**PUR-1270  
ADDENDUM NO. 4  
INVITATION TO BID**

**CONOCOCHEAGUE TREATMENT PLANT ENR UPGRADE**

**DATE: Thursday, May 19, 2016**

DRAWING NO:  
**S-3**  
SHEET NO:  
101 OF 327  
SP-15-028

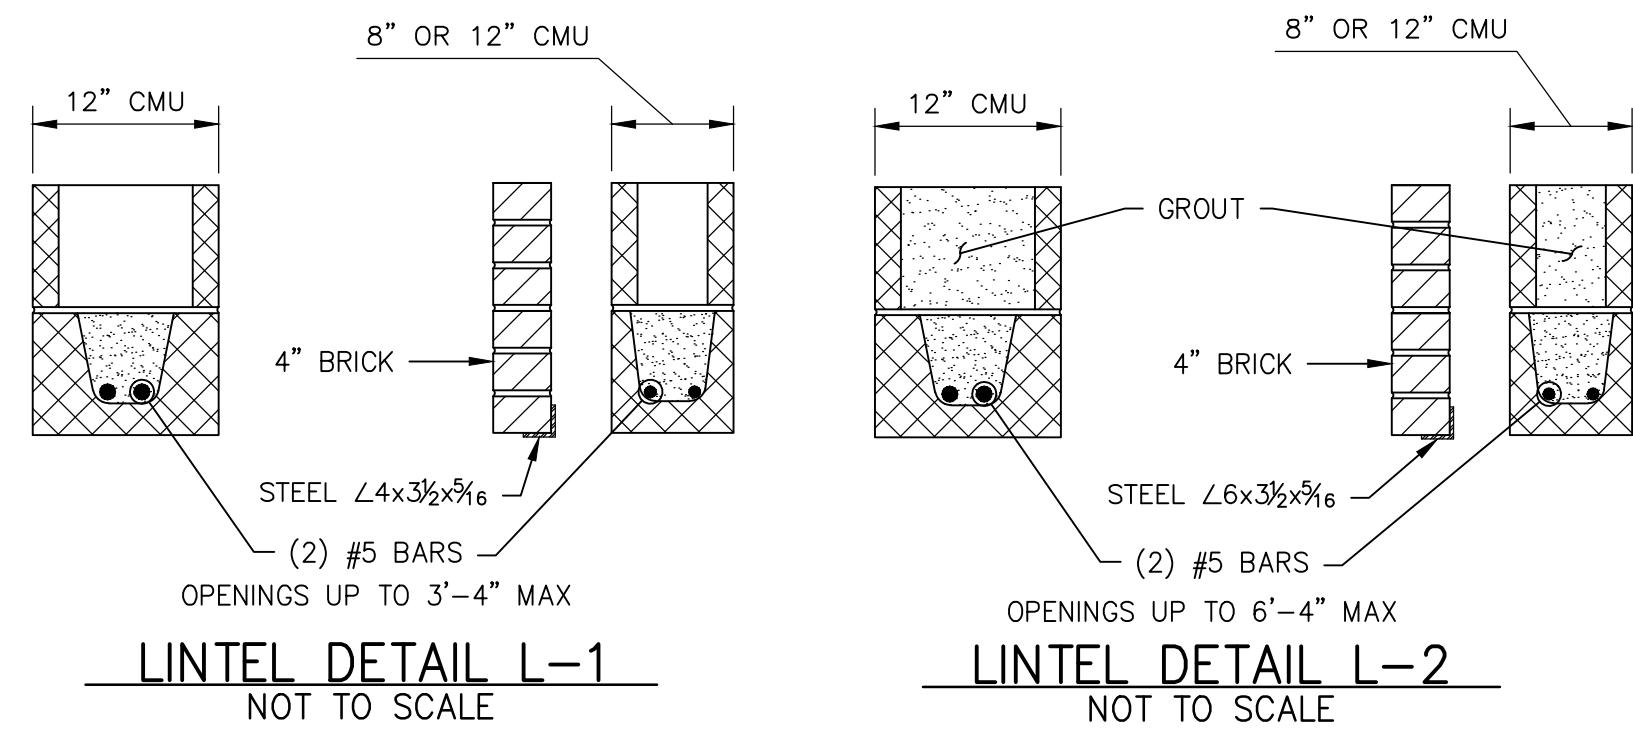
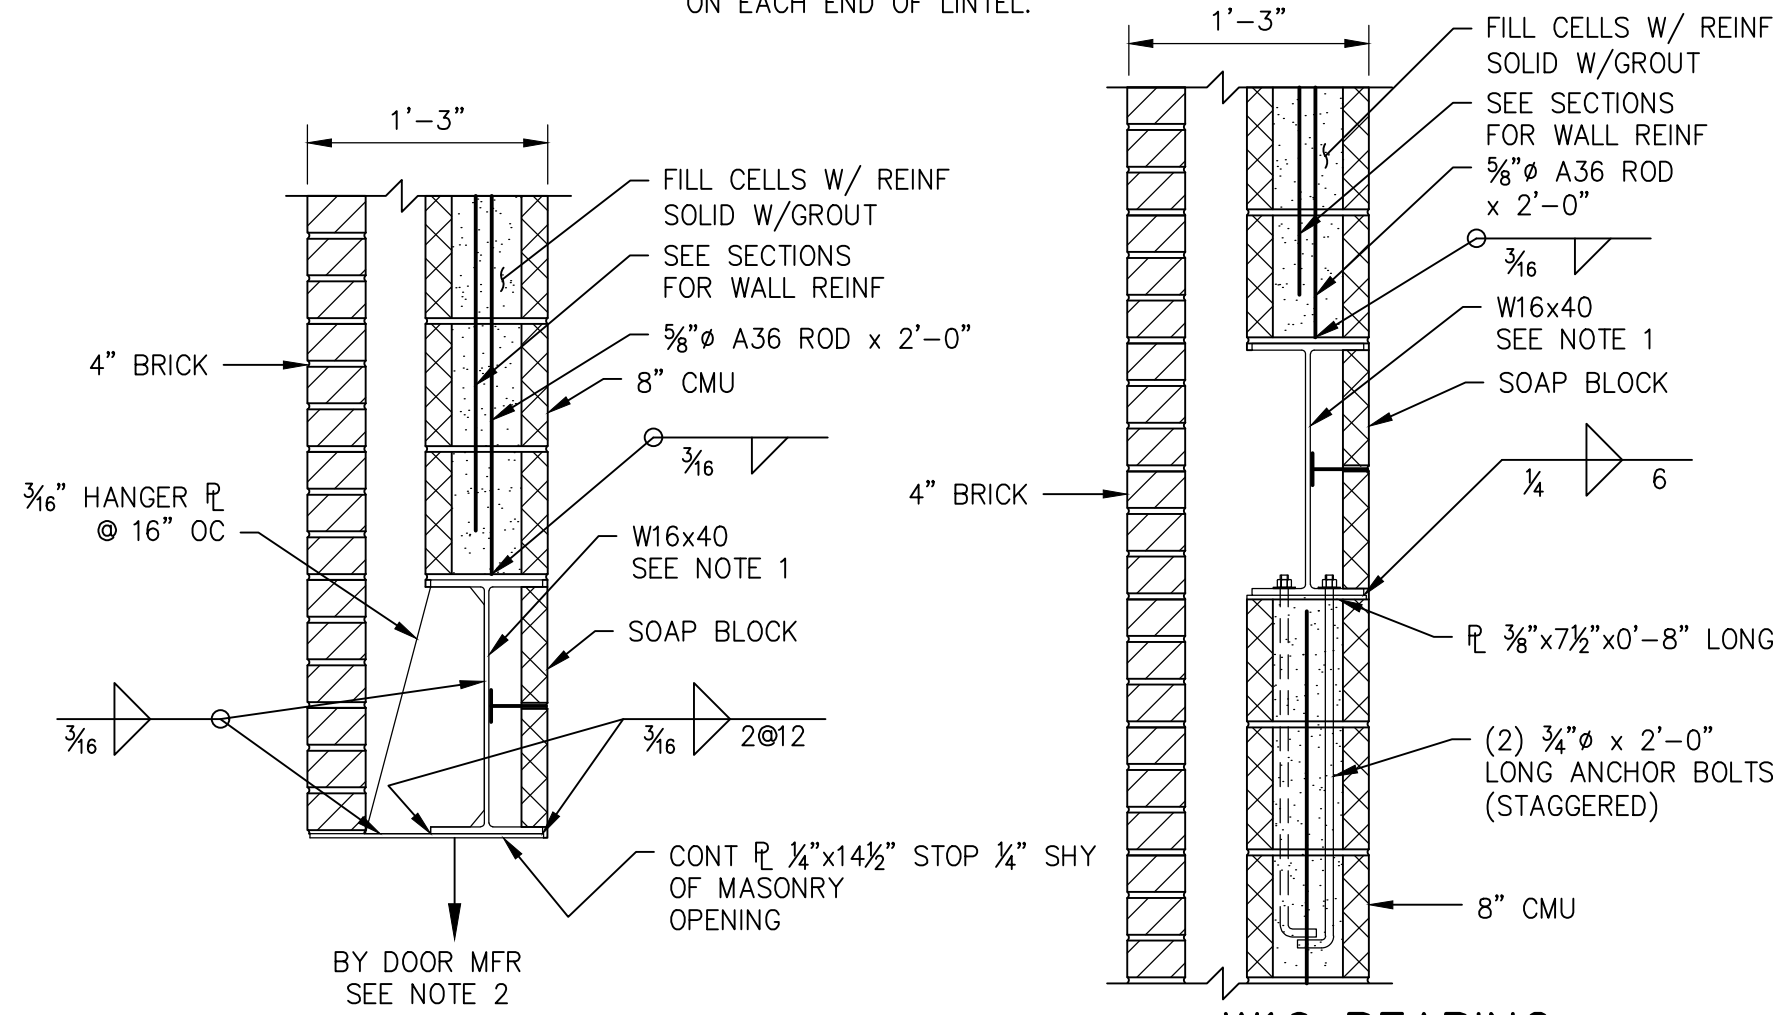
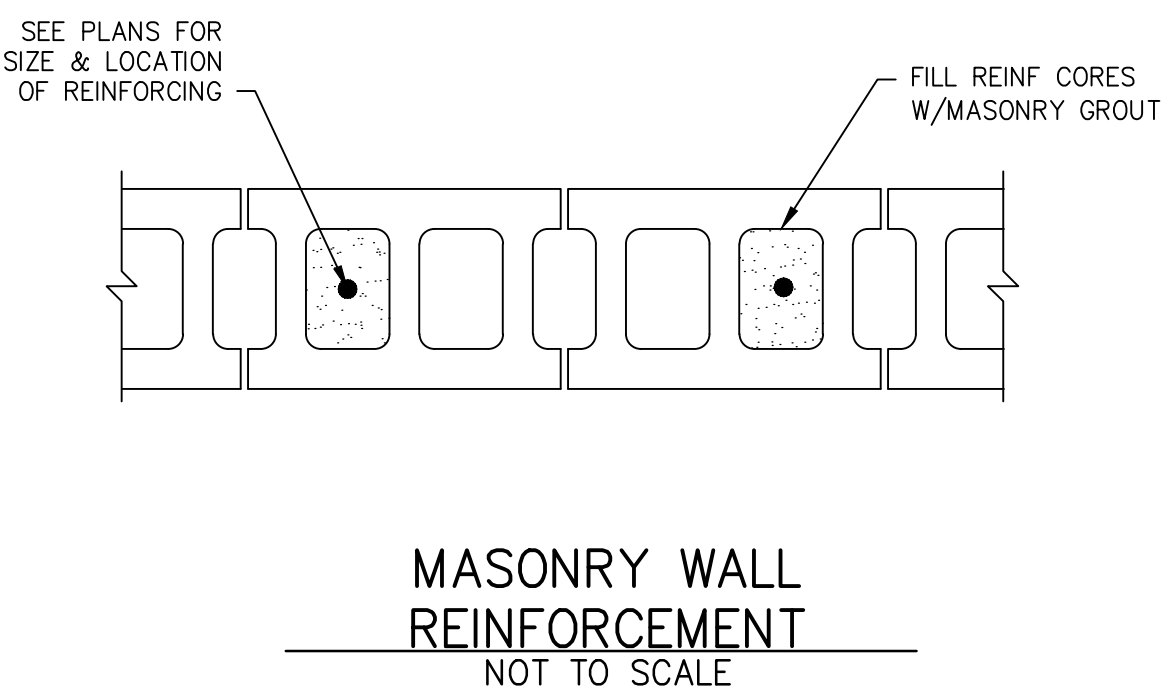
*Response:* There are standard lintel details on the revised S-3.

**9 SECTION**  
S-16 SCALE: 1/2" = 1'-0"

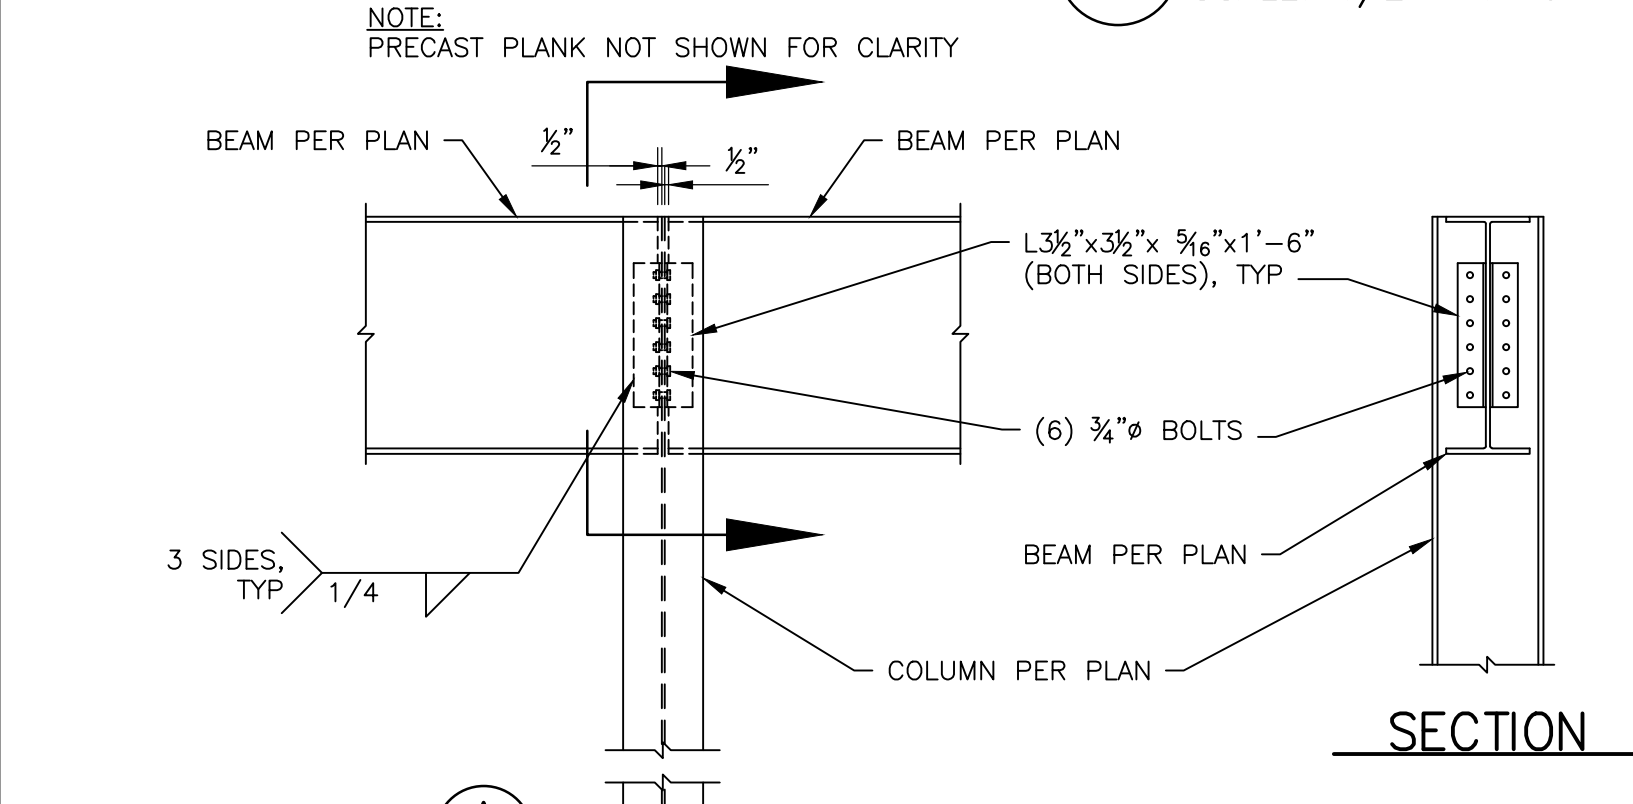
**ITEM NO. 58:** *Inquiry:* Biomag building 9/S-18 elevation varies bearing note , if this were correct would the bond beam need to cut to the bearing heights ?

*Response:* Since the roof planks are flat (not pitched), the bond beam will be positioned at a constant elevation. Therefore, the bond beam will not need to be cut. See revised Section 9/S-18 attached.

DRAWING NO. **E-3**  
 SHEET NO. 141 OF 327  
 SP-15-028

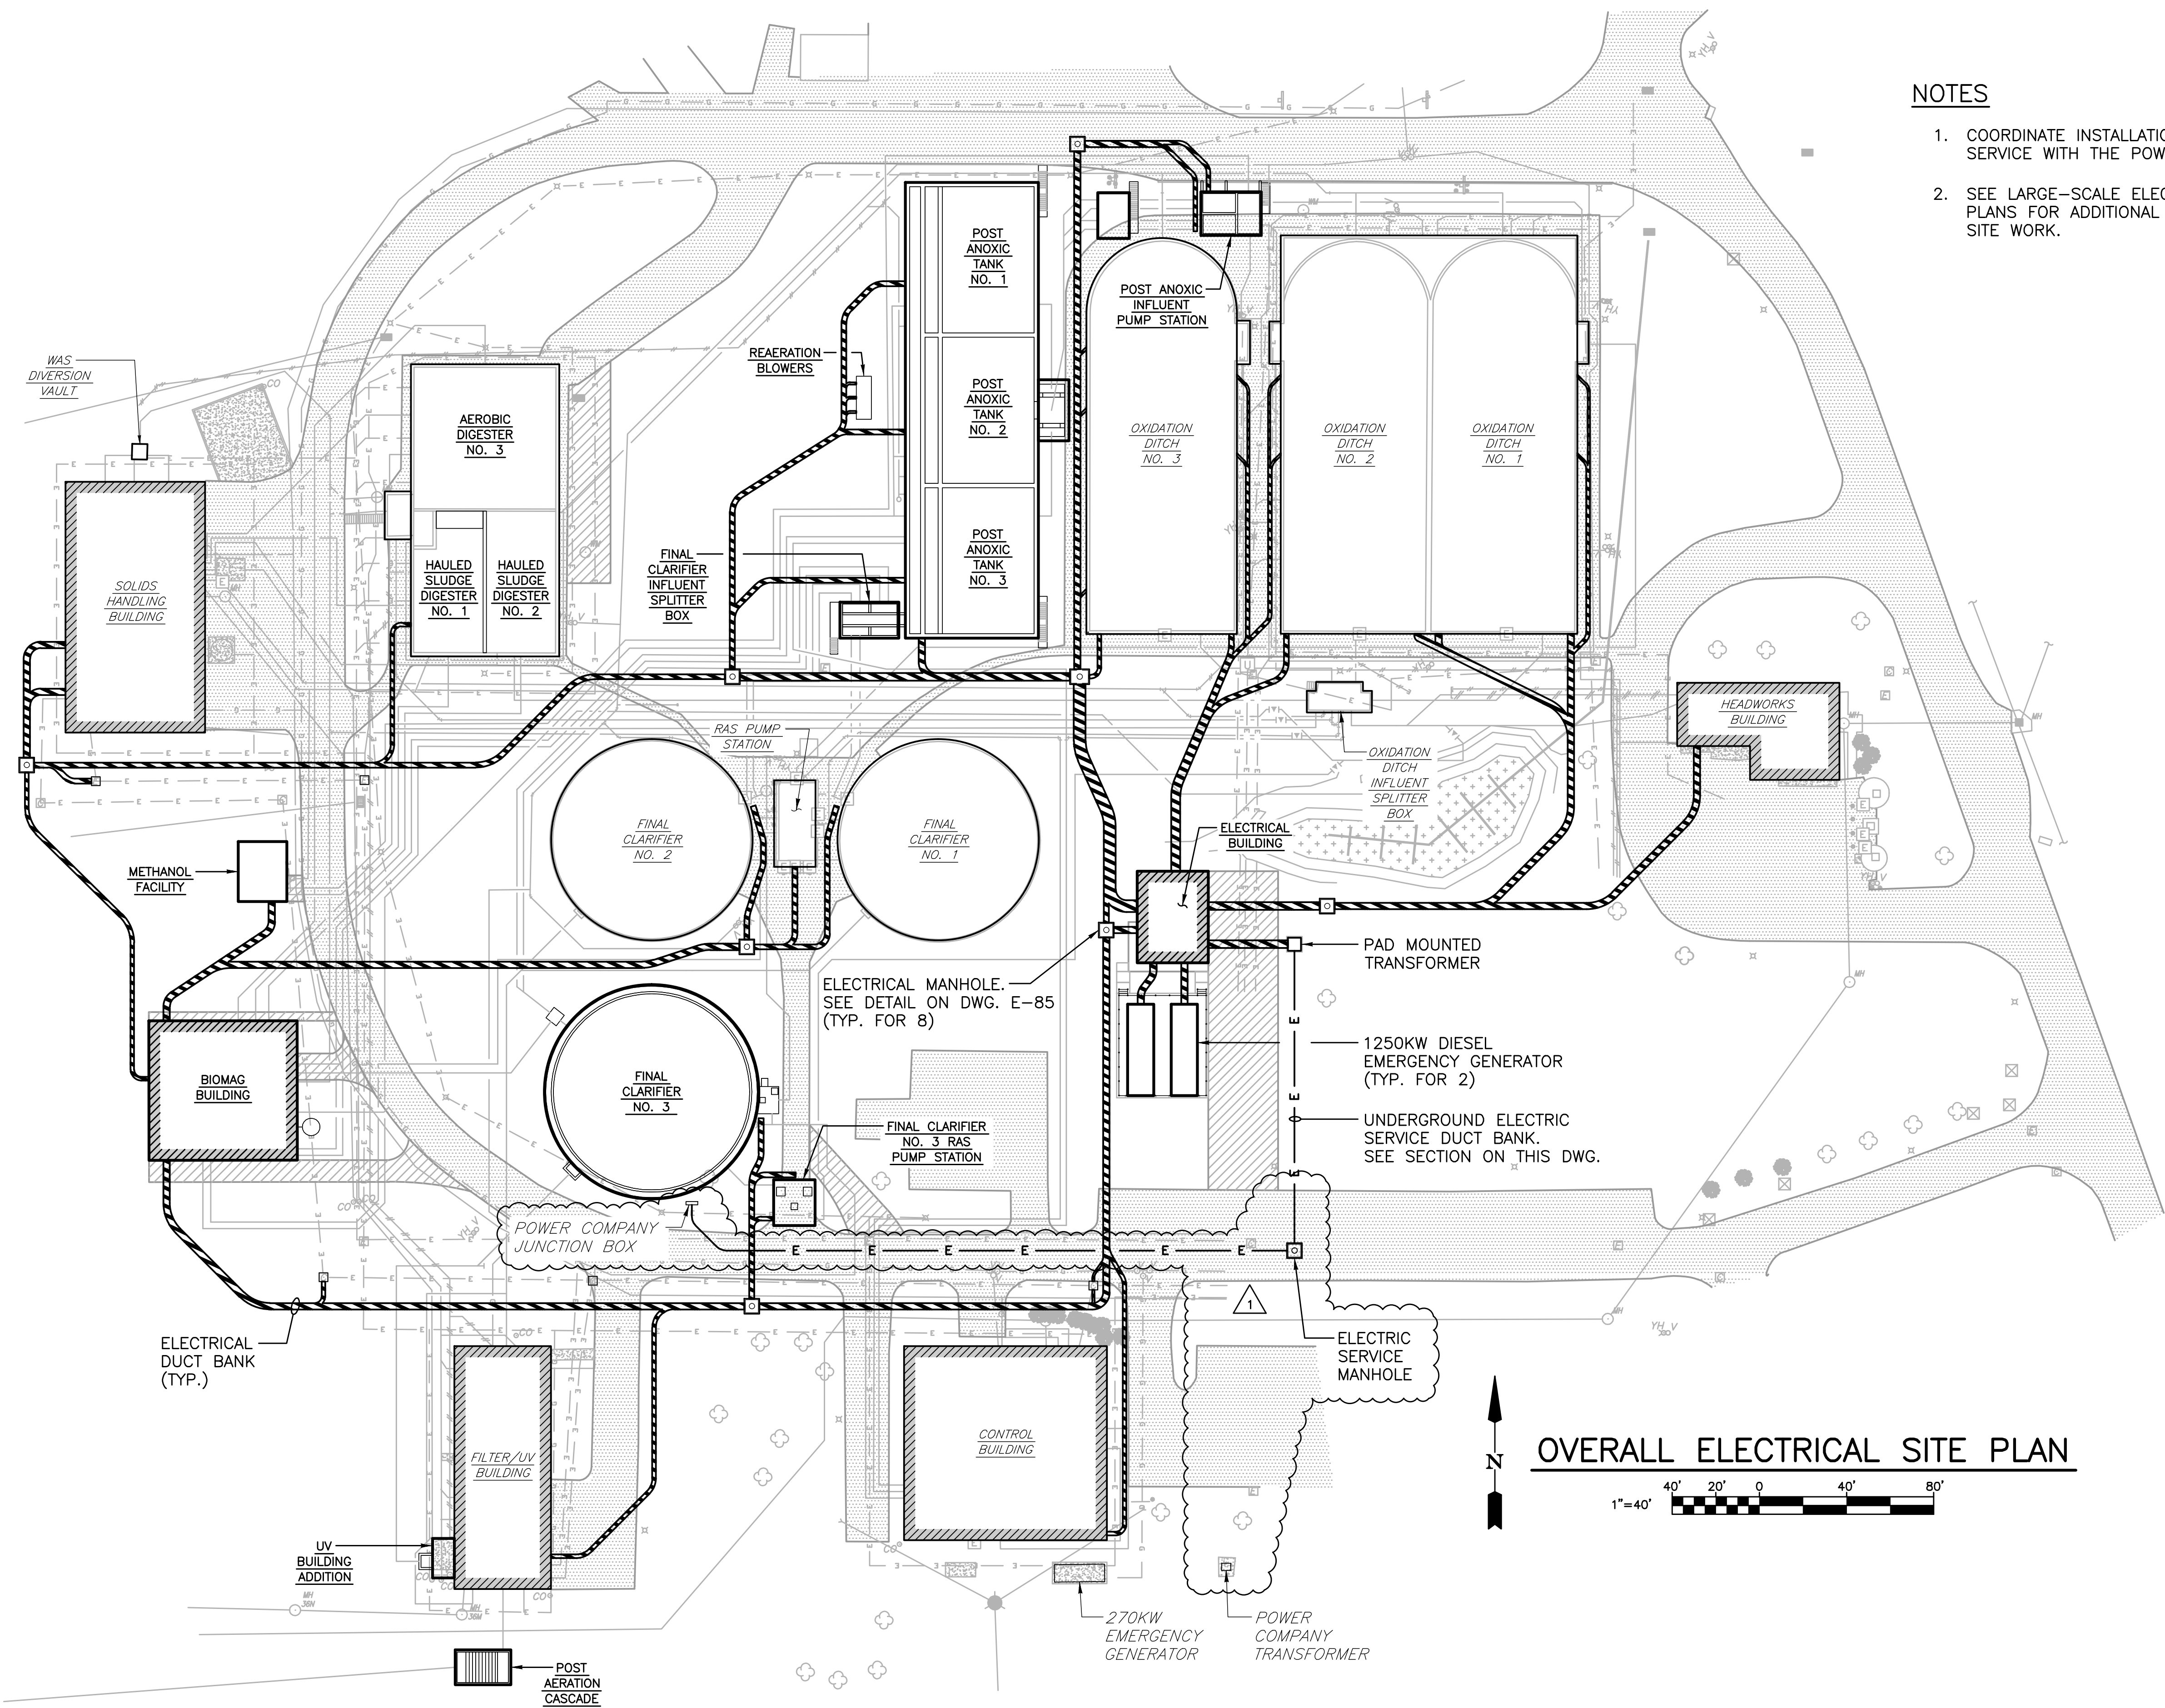
Drawing No. E-3, Overall Electrical Site Plan - **CHANGE** the underground electric service duct bank as shown on the attached drawing, and **ADD** an electric service manhole to the duct bank run. The electric service will originate from the power company junction box located to the south of Final Clarifier No. 3. This revision applies to the large scale electrical site plans.
